Wollongong Local Planning Panel Assessment Report | 9 June 2020

WLPP No.	Item No. 2
DA No.	DA-2019/1123
Proposal	Demolition of existing structures and construction of a 14-storey mixed use development comprising 50 residential units 1 ground floor commercial tenancy and two levels of basement parking
Property	35-37 Atchison Street, WOLLONGONG
Applicant	Design Workshop Australia
Responsible Team	Development Assessment and Certification – City Centre Team (RW)

ASSESSMENT REPORT AND RECOMMENDATION

Figure 2: Floor plan showing typical separation distance between the residential towers on the subject site and 31-33 Atchison St to the north

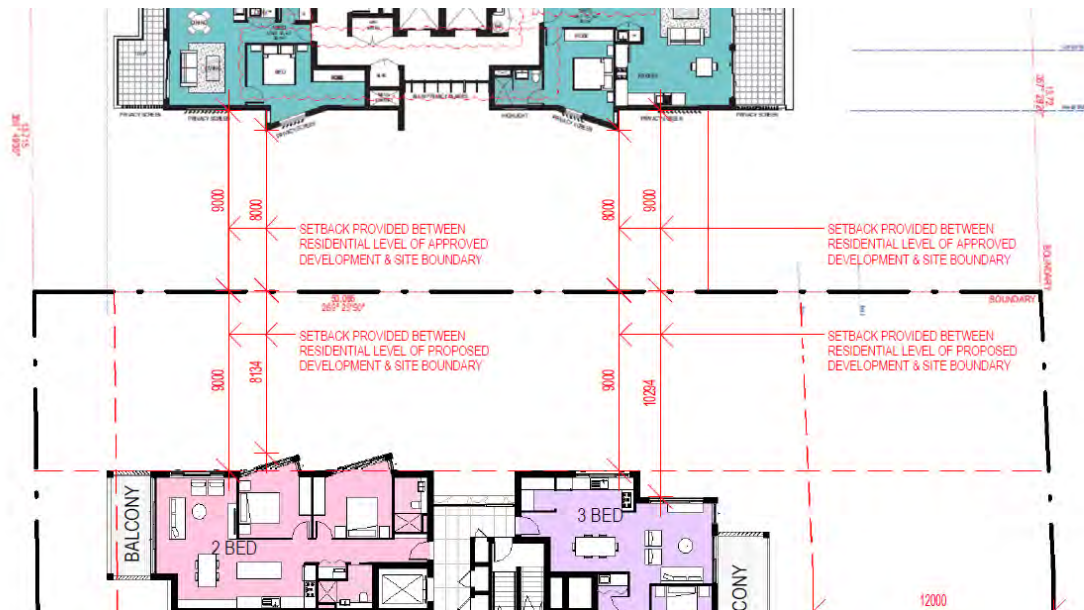
The residential tower from Level 2-Level 13 maintains a 9m setback from the northern boundary to all levels, with angled windows encroaching into the 9m setback at a minimum distance of 8.04m. The development at 31-33 Atchison Street (under construction) has a similar setback to its southern boundary, resulting in a separation distance of between 16m-18m between the two sites.

Figure 4: Part Level 1 plan showing dwellings within the podium with a zero (0m) side setback to the southern boundary (adjoining the church site at 39 Atchison St)

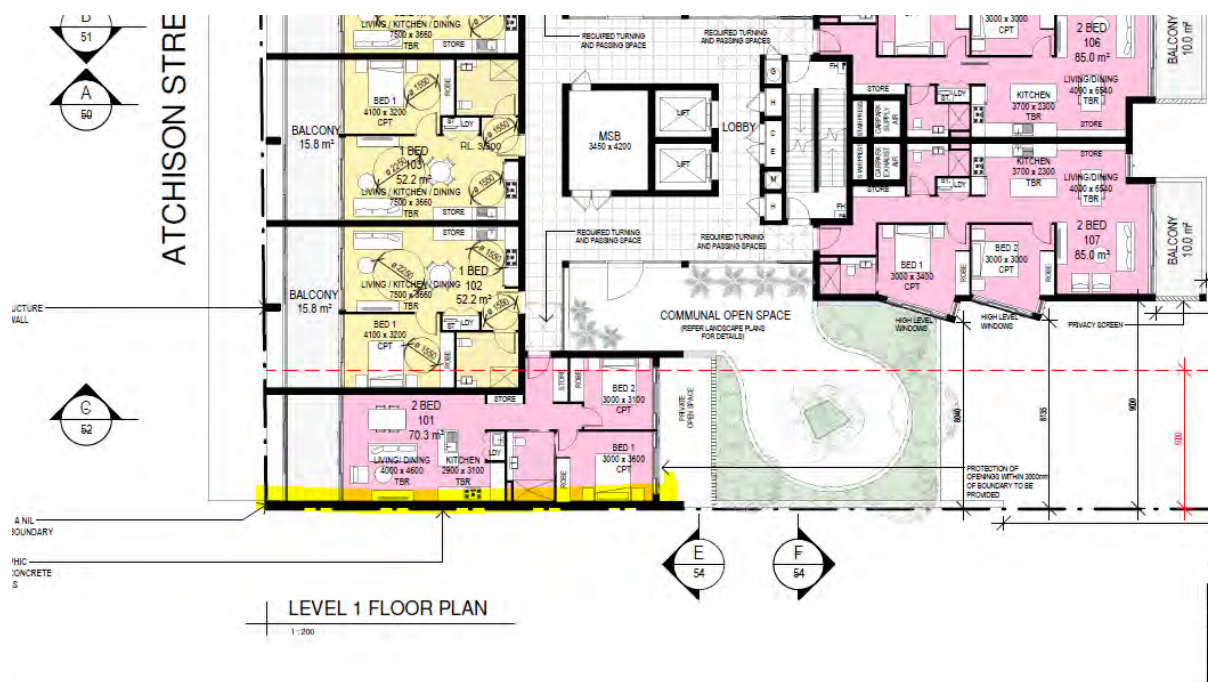
Above the podium, the tower has a setback to the southern boundary of between 8.04m-9m which equitably shares the minimum separation distances if this site is redeveloped for commercial purposes in the future (i.e. achieving a 16m separation distance), however would require an 11m-12m setback to the northern boundary of 39 Atchison Street to comply with the 20m separation distance under subclause 3(a) in the event that dwellings are proposed as part of a redevelopment.
